Champaign County Department of PLANNING & ZONING Brookens Administrative Center 1776 E. Washington Street Urbana, Illinois 61802 (217) 384-3708 zoningdept@co.champaign.il.us www.co.champaign.il.us/zoning	CASE NO. 057-V-22 SUPPLEMENTAL MEMORANDUM #3 October 25, 2022 Petitioner: Angel Corado				
	Request: Authorize a variance for the construction and use of an accessory structure with an average height of 17 feet 9 inches in lieu of the maximum allowed average height of 15 feet in the R-3 Two-Family Residence Zoning District, per Section 5.3 of the Champaign County Zoning Ordinance.				
	Subject Property:	A 0.46-acre lot that is the South Half of Lot 38 in Fred C. Carroll's Subdivision of the East Half of the Northwest Quarter of the East Half of Section 9, Township 19 North, Range 9 East of the Third Principal Meridian in Urbana Township, commonly known as the residence with an address of 1206 Carroll Avenue, Urbana.

- A Email from Mark Miller, Precision Engineering, received October 24, 2022, with attachment:
 - Revised drainage system plan

FILE #	11022002	SHEET	2 OF 2	
	STORM SEWER BASIN EXHIBIT 1206 CARROLL AVE URBANA, ILLINOIS				
	PRECISION ENGINEERING GROUP, INC.	P.O. BOX 78

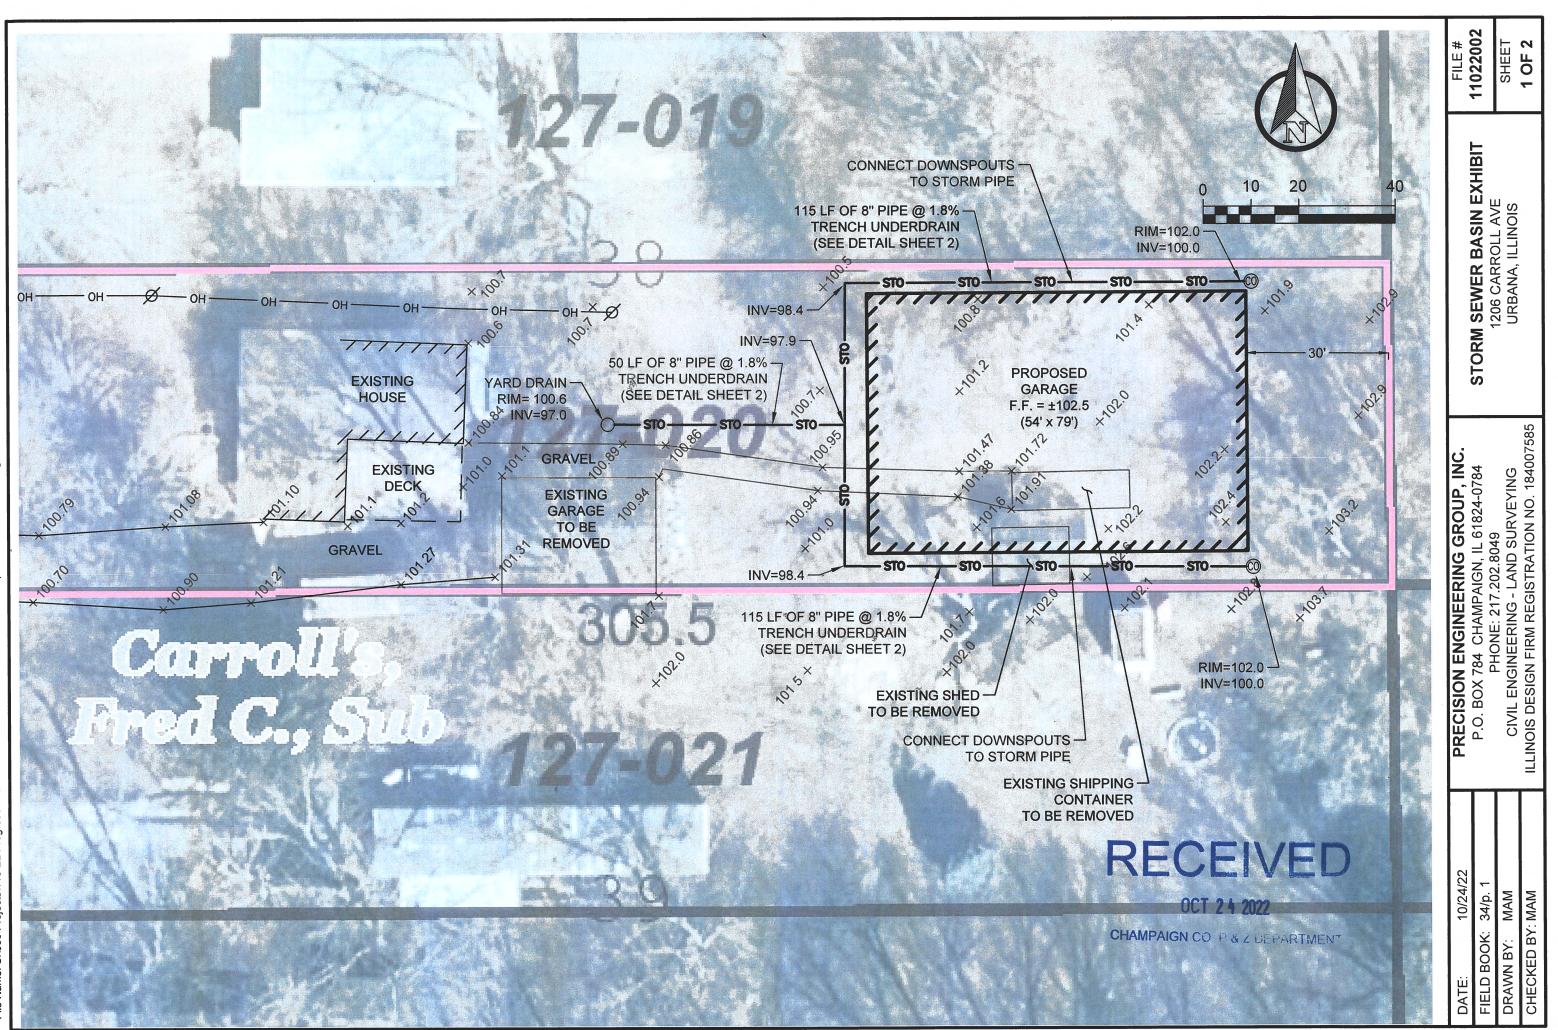
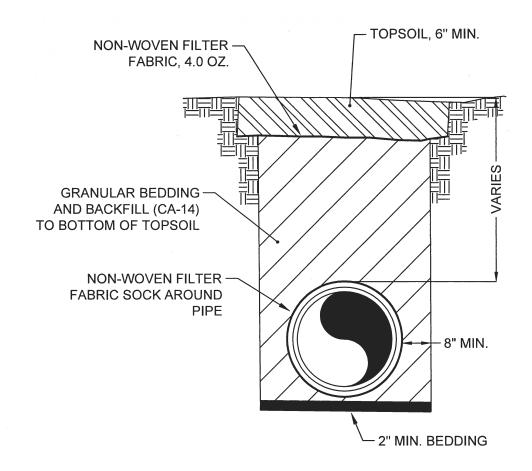
- 1. Can the north yard drain be brought toward the middle of the yard rather than going parallel to the property line? Pipe revised to wrap around garage and then runs west to the middle of the yard.
- 2. Can the building be set back between 10 and 20 feet from the east property line so as to have more yard on the west side of the building? Set garage 30' west of the property line to minimize removing trees.

Mark Miller, engineer for Mr. Corado, responded to the Board's questions in an email received October 24, 2022 (Attachment A). He also updated the site plan by moving the proposed detached shed to be 30 feet from the east property line and moved the trench underdrain and yard drain to the center of the lot.

Susan – we have revised the plan to show the garage further east. We kept it 30' west of the property line to try and save some of the trees along the property line. See below in red for responses. Please let us know if you have any questions or require additional information.
